COA (SP) 2017-015  
August 17, 2017

Historical Resources &  
Cultural Arts

**STAFF REPORT  
SPECIAL CERTIFICATE OF APPROPRIATENESS  
FOR THE PROPERTY AT  
1206 CORDOVA STREET  
A LOCAL HISTORIC LANDMARK**

**Front (East) Façade, along Cordova Street:  
c. 1940 historic photo [top], 2017 current photo [center]:**

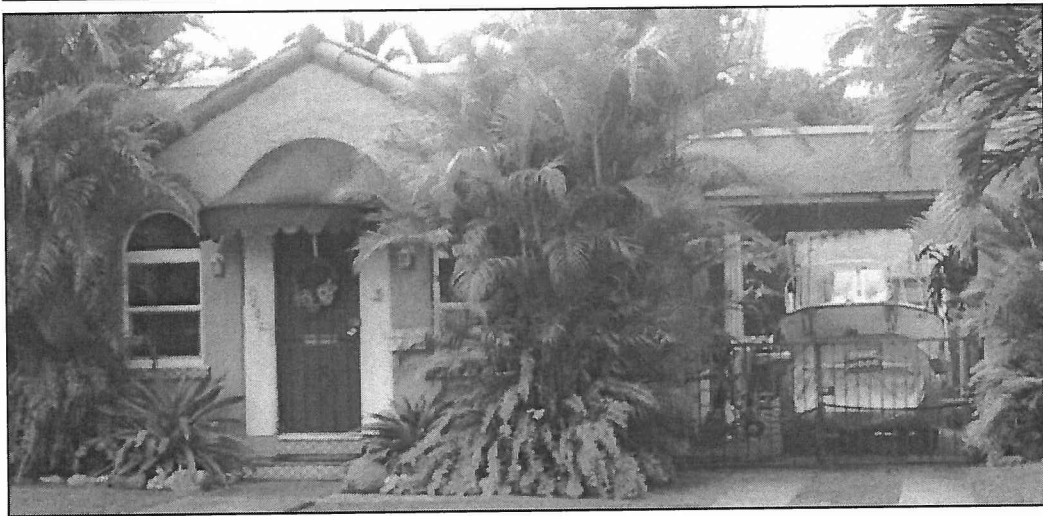
On the primary (east) façade facing Cordova Street, the addition protrudes approximately 18" to the south of and rising approximately 12" above the existing residence. The addition extends the home to the west approximately 33'-6." On the extant structure, the existing front door and security gate will be removed. The front door is not original (an arched screen door with screen sidelights originally filled the opening). An arched impact-resistant door set within a recess will allow the original arched opening to be maintained and the door shape is reminiscent of the original screen door. The existing impact-resistant windows (installed prior to designation) will remain throughout the residence unless otherwise specified. The existing porte-cochere to the north is proposed to be removed. Extending to the north and south of the existing residence, a 4'-0" high masonry wall inset with gates will be constructed. The metal pedestrian gate to the south and vehicular gate to the north are detailed to match those proposed at the east property line. The garage is visible from this elevation, however discussion of the garage will be occur later within this report.

1. The stucco banding located at the parapet of the new addition should be different than that found on the existing residence or removed entirely.
2. The new tile roof is to be true, two-piece barrel tile.
3. The extant structure is not to be restuccoed in its entirety, but patched as needed. The stucco texture on the addition is to be differentiated from the existing stucco finish.
4. If acceptable impact-resistant carriage doors (with Miami-Dade County NOAs) are not located, the existing garage doors are to be repaired, or if too damaged replicated, and secured with hurricane shutters.
